# **S4.55(1A) MODIFICATION REPORT**

Doncaster Ave, Kensington

Prepared for  
**COR PARTNERS**  
7 December 2021

Figure 1 Approved and proposed cluster rooms

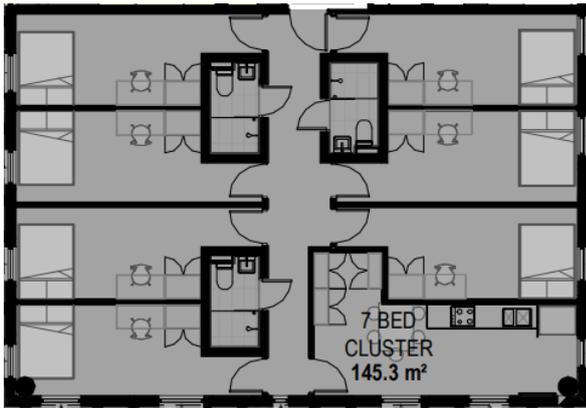
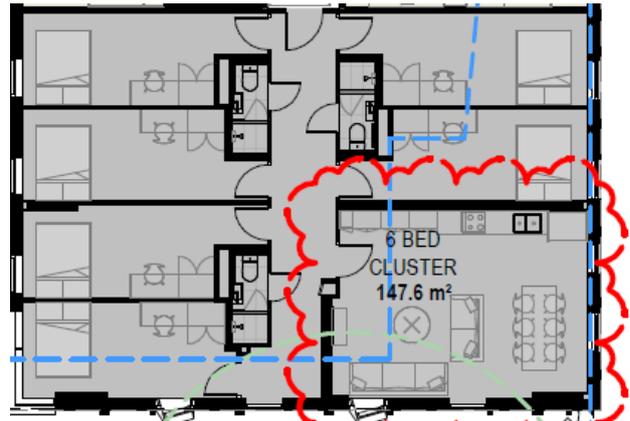
- **Redesign of the five 7 bed clusters into 6 bed clusters**

It is proposed to reconfigure the five approved seven bed clusters into six bed clusters. The proposed modification to the design will provide a larger common area within the clusters as shown in **Figure 1**.
